**North Carolina Department of Transportation  
PROJECT ENVIRONMENTAL CONSULTATION FORM  
I.D. No. U-2525 B**

- a. Consultation Phase: Right of Way
- b. Project Description Greensboro Eastern Loop from North of US 70  
Relocation to US 29 North of Greensboro
- c. WBS Element Number 34821.1.1
- d. Document Type: State Final Environmental Impact Statement, August 12, 1994  
State Record of Decision, March 7, 1995

Greensboro Eastern Loop from North of US 70 Relocation  
to US 29 North of Greensboro  
Guilford County  
WBS Element 34821.1.1  
**TIP Project U-2525 B**

### KERENOFF NEIGHBORHOOD ACCESS

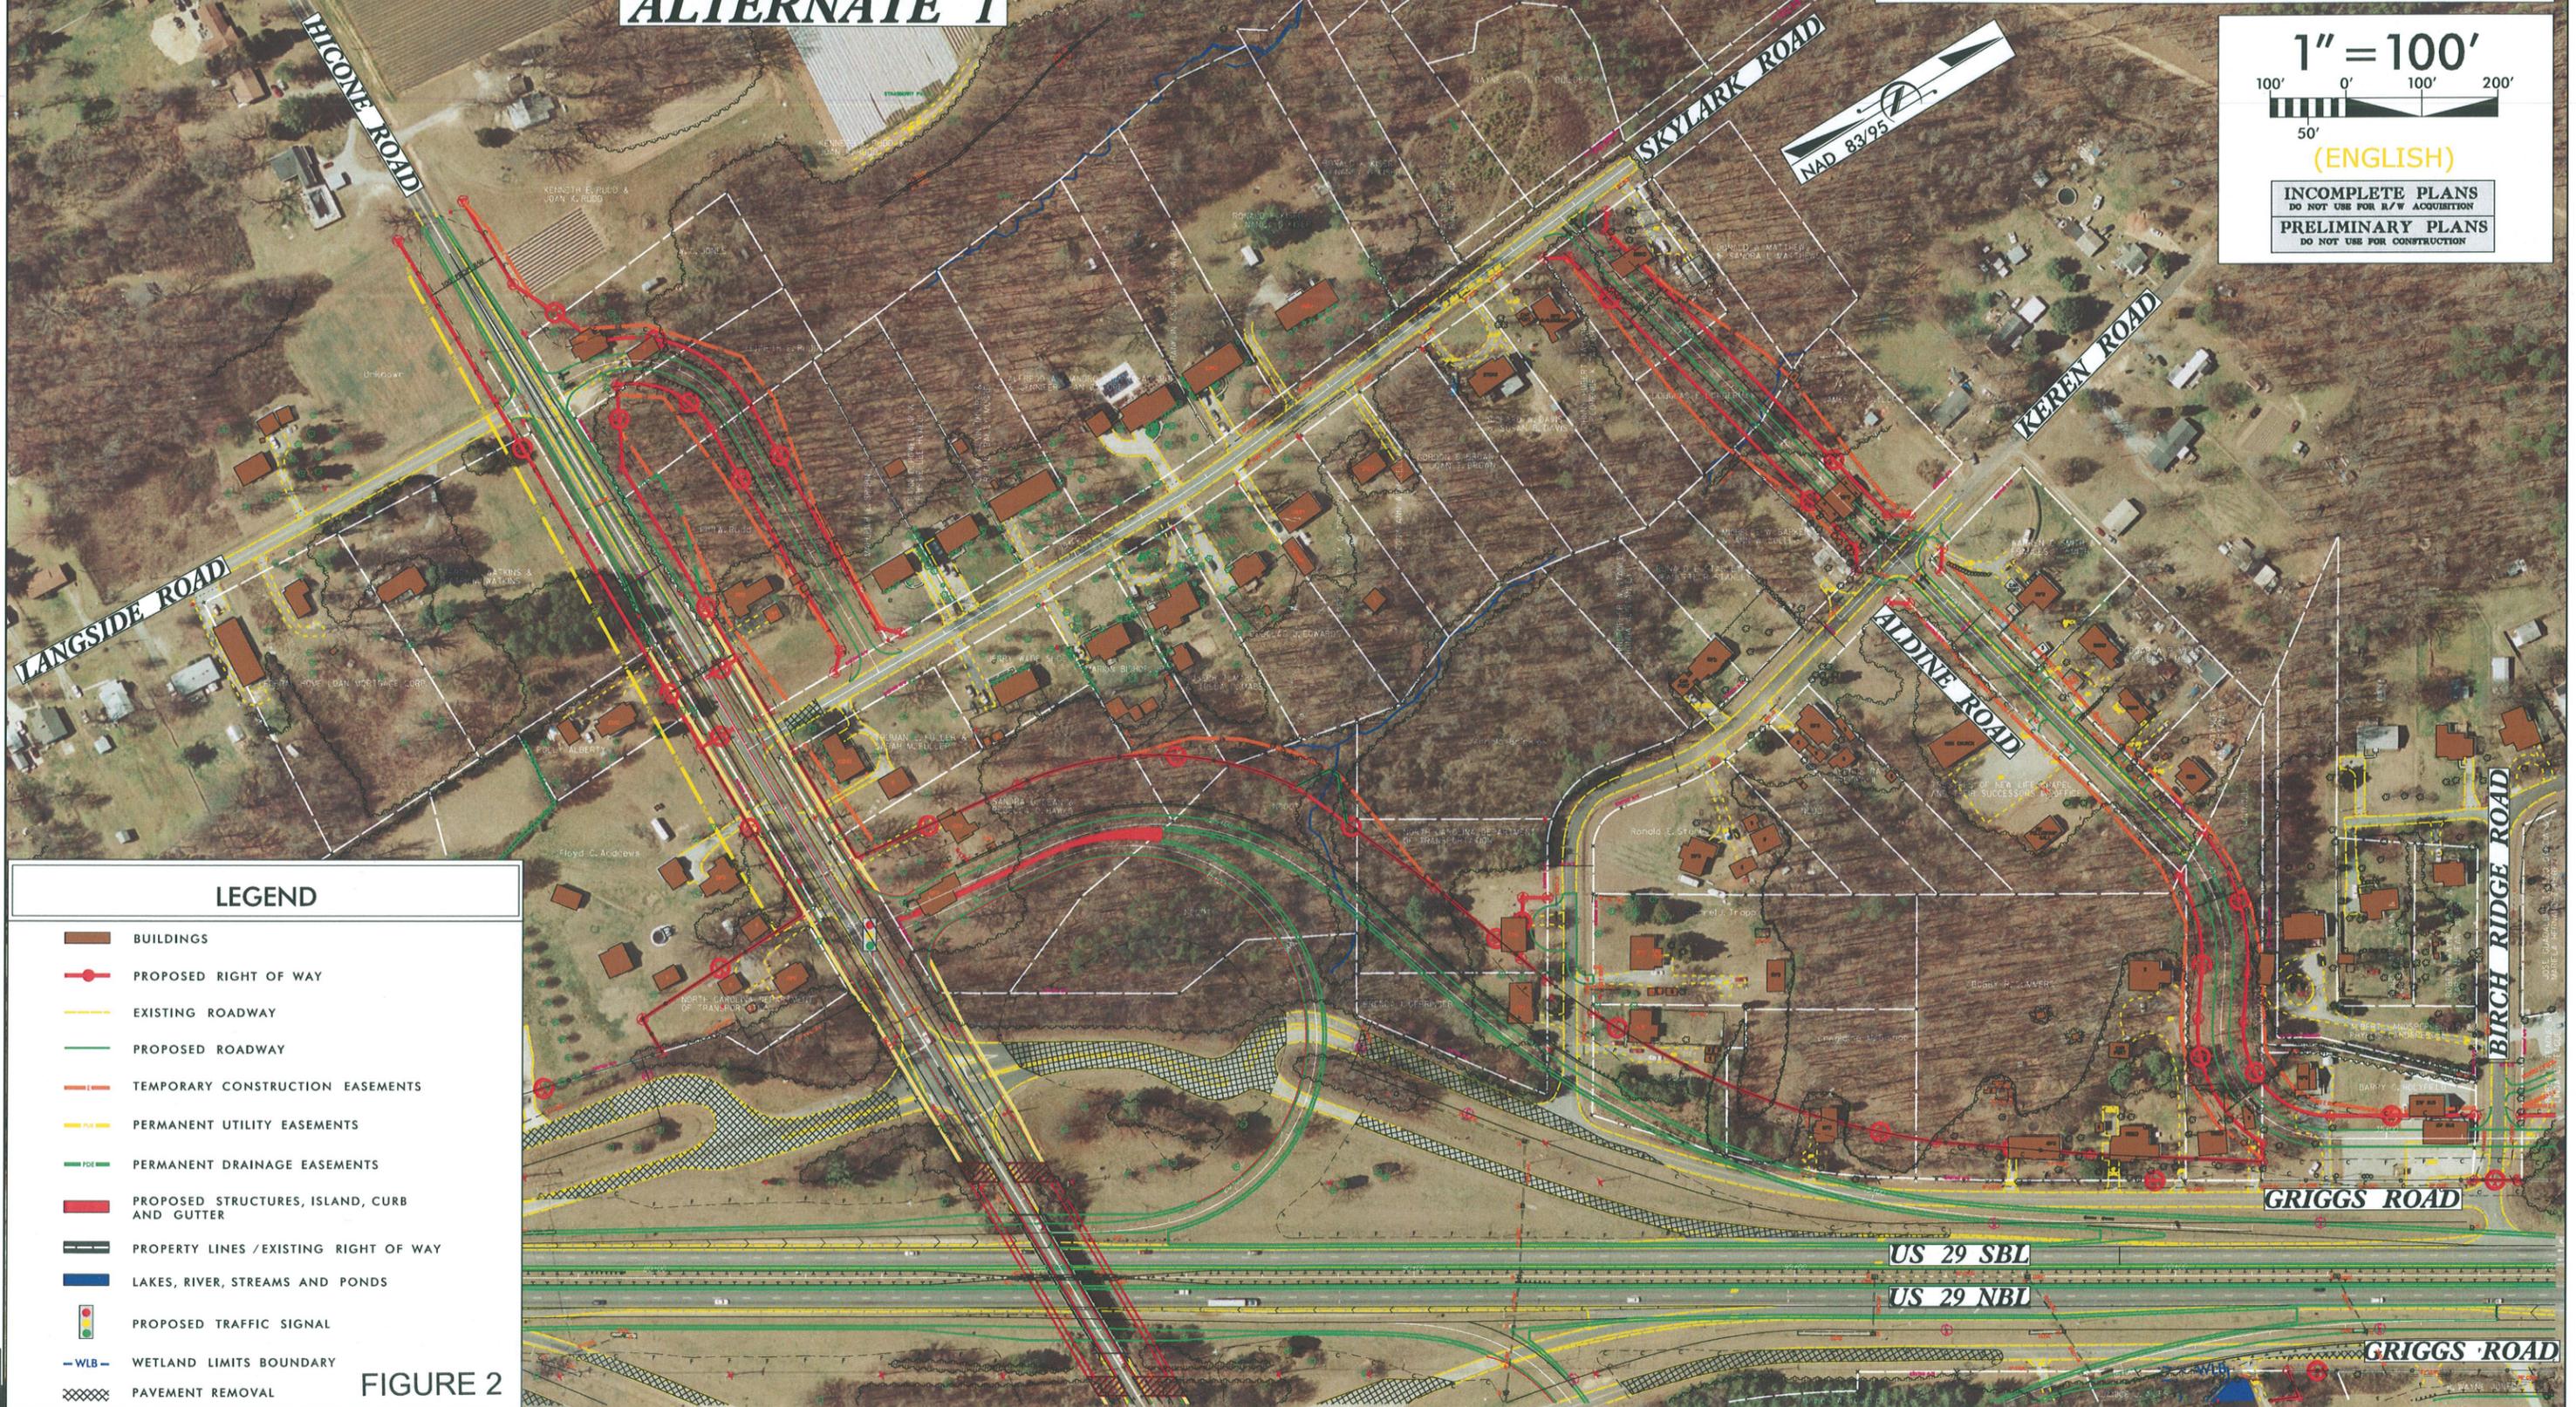
The Kerenoff neighborhood service road near Birch Ridge Road and the US 29 / Hicone Road interchange was redesigned at the neighborhood's request to provide more residents in the area with an additional access to US 29 via the US 29 / Hicone Road interchange. This service road redesign will displace three homes and generate 170 feet of additional stream impacts. Noise analyses which included Traffic Noise Modeling were performed, and the results showed that there are no anticipated noise impacts in accordance with NCDOT's July 2011 Traffic Noise Abatement Policy; therefore, noise abatement is not required for the subdivision. A meeting is scheduled with the neighborhood to discuss the service road redesign.
